## Agenda Item # 14

SUB-003482-2025, SUB-SW-003519-2025 & ZON-UDC-003518-2025

Addition to First Baptist Church of Theodore  
Subdivision

- Subdivision approval to create two (2) legal lots of record.
- Request to waive the construction of a sidewalk along Bellingrath Road.
- Rezoning from R-1, to R-1 & B-4
  - Any use permitted in the proposed district would be allowed at this location if the zoning is approved. The Planning Commission may consider other zoning districts than the proposed sought by the applicant for this property.

# DETAIL SITE PLAN

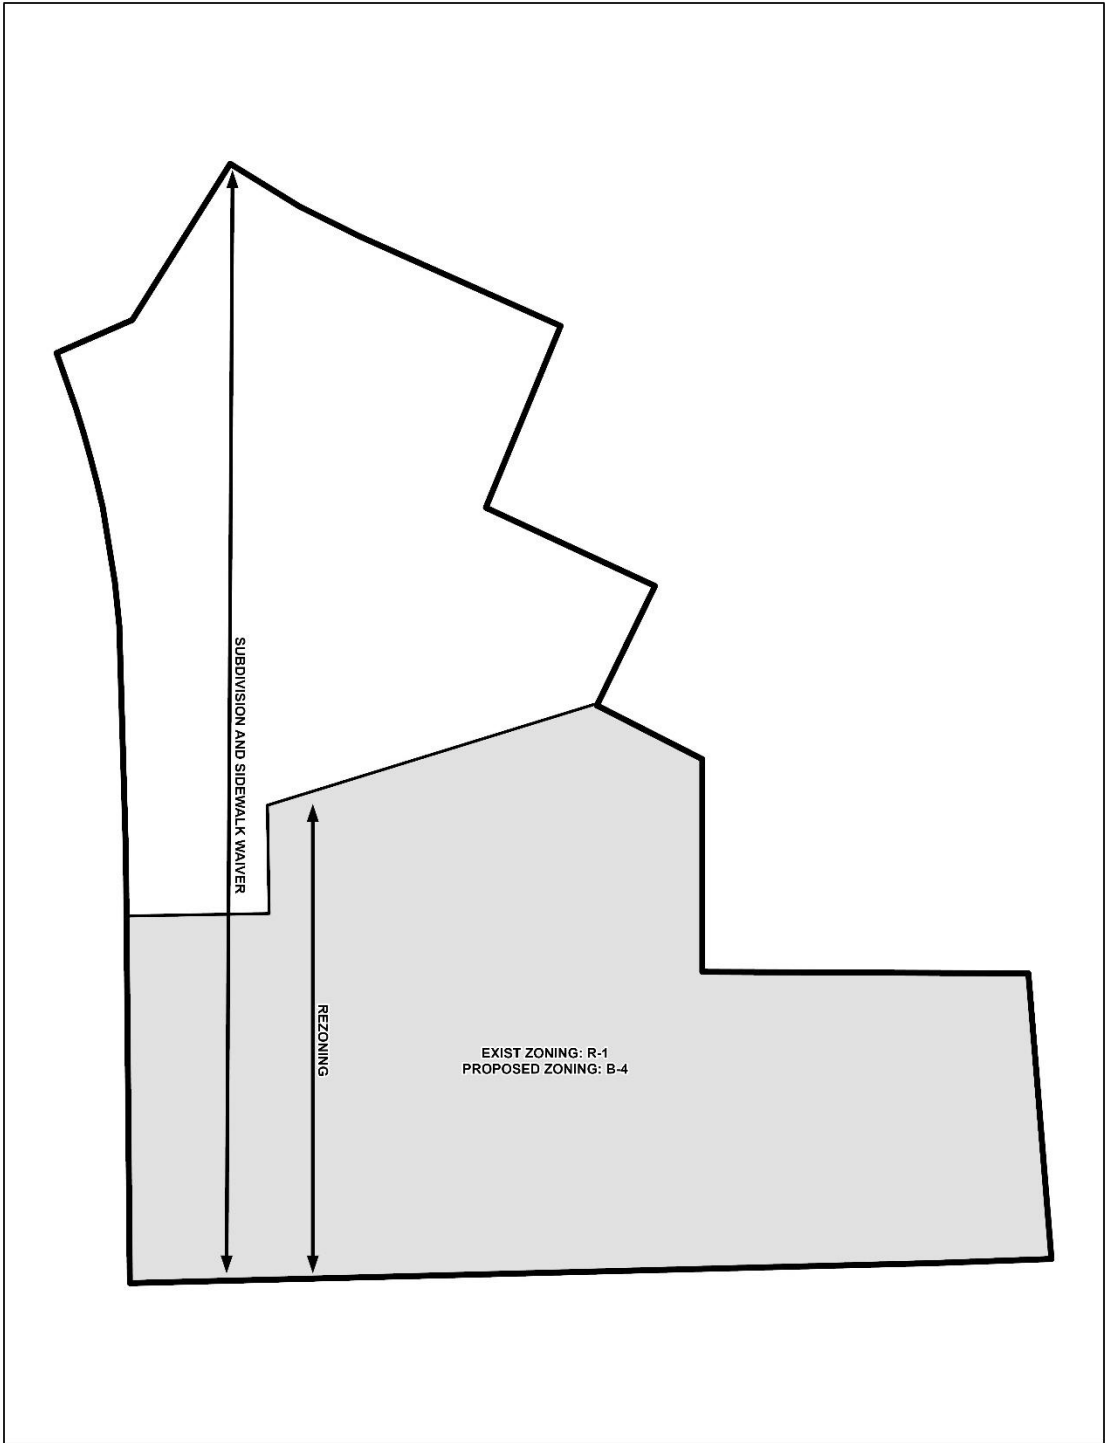
- B. Delete ENGINEERING NOTES #6 and insert “As shown on the 1984 aerial photo (Flight 21 #97) LOT 1 and LOT 2 will share the historical credit of existing (1984) impervious area towards stormwater detention requirement per Mobile City Code, Chapter 17, Storm Water Management and Flood Control) as follows: LOT 1 – 18,000 SF and LOT 2 – NONE.”

- C. Retain NOTES 7 – 9, 13, and 15.
- D. Email a pdf copy of the FINAL SUBDIVISION PLAT and LETTER OF DECISION to the Permitting Engineering Dept. for review at [land.disturbance@cityofmobile.org](mailto:land.disturbance@cityofmobile.org) prior to obtaining any signatures. No signatures are required on the drawing.

The current plat illustrates a 45-foot front yard setback along Bellingrath Road and a 35-foot setback along Old Military Road, consistent with the most recently recorded subdivision plat. Therefore, a renewed waiver of Section 6.B.9. may again be appropriate. If approved, these increased setbacks should be retained on the Final Plat.

Proposed Lot 2 constitutes a double-frontage lot, which is generally discouraged by Section 6.C.7. of the Subdivision Regulations. Nonetheless, previous subdivision approvals permitted this configuration, suggesting that a waiver of Section 6.C.7. may be appropriate.

Both lots exceed the minimum area and size requirements for lots served by public water and sanitary sewer within the site's existing and proposed zoning classifications. Lot dimensions and area are correctly labeled in both square feet and acres on the preliminary plat, in compliance with Section 5.A.2(e)(4) of the Subdivision Regulations. This information should be retained and updated on the Final Plat to reflect any required dedications.

1. Retention of the 45-foot front yard setback along Bellingrath Road and the 35-foot front yard setback along Old Military Road on the Final Plat, consistent with the most recently recorded subdivision plat;

2. If any additional right-of-way dedication is required by the City Engineer, the Final Plat should illustrate a minimum 25-foot front yard setback along any affected street frontage, in compliance with Section 6.C.8. of the Subdivision Regulations;

3. Retention of the lot sizes in both square feet and acres on the Final Plat, consistent with Section 5.A.2(e)(4), adjusted for any required dedication;
